Access Compliance Report

Public Rights-of-Way

(Curb Ramps)

Intersection ID: 10025331	Main Street: E_5TH_ST	Cross Street: N/A	Location: SW
ADA ID: BDC866EF11E1	Ramp Type: BlendTrans2	Initial Pass/Fail: Fail	Overall Compliance: No
		Severity Score: 8.75

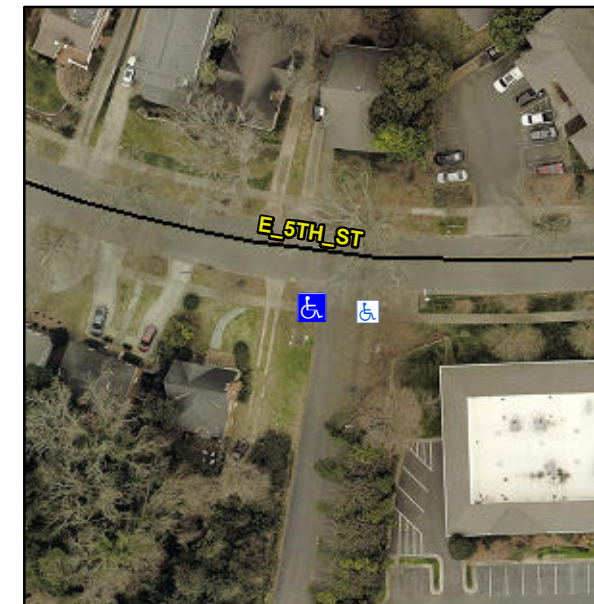
Not Found, R304.5.1

Compliance	Description	Data	Compliance	Description	Data
N/A	Ramp Length (in)	69.0	Yes	BlendTrans Slope (%)	2.9
No	Ramp Width (in)	38.0	Yes	BlendTrans XSlope (%)	1.3
N/A	Flare Type LT	N/A	N/A	Flare Type RT	N/A
N/A	Flare Slope LT (%)	N/A	N/A	Flare Slope RT (%)	N/A
N/A	Flare Traversable LT?	N/A	N/A	Flare Traversable RT?	N/A
N/A	Landing Length (in)	N/A	N/A	DWS Provided?	N/A
N/A	Landing Width (in)	N/A	N/A	DWS Contrast?	N/A
N/A	Landing Slope (%)	N/A	N/A	DWS Length (in)	N/A
N/A	Landing X Slope (%)	N/A	N/A	DWS Full Width?	N/A
N/A	Landing Curb? (Y/N)	N/A	N/A	DWS Offset (in)	N/A
N/A	Shared Landing?	N/A			
N/A	Gutter Ponding?	N/A	N/A	Gutter Slope (%)	N/A
N/A	Gutter Lip Ht (in)	N/A	N/A	Gutter X Slope (%)	N/A
N/A	Painted X Walk1?	No	N/A	Painted X Walk2?	No
	X Walk 1 Direction	To E		X Walk 2 Direction	To N
	X Walk 1 Width (in)	N/A		X Walk 2 Width (in)	N/A
	X Walk 1 Slope (%)	2.1		X Walk 2 Slope (%)	0.8
	X Walk 1 X Slope (%)	1.4		X Walk 2 X Slope (%)	1.7

N/A	Ramp inside XWalk1?	N/A	N/A	Ramp inside XWalk2?	N/A
	Road Slope (%)	2.3		Clear Space?	N/A
	Road X Slope (%)	0.1	N/A	Clear Space to XWalk (in)	N/A
N/A	Any Obstructions?	N/A	N/A	Storm Grate/Utility Hazard?	N/A
	Obstruction Type			Storm Grate/Utility Type	
		N/A			N/A
			Yes	Surface Condition? (G/P)	Good
			No	Curb Slope (%)	13.2

Remove & Replace Curb Ramp With Two New Directional Ramps or Equivalent.
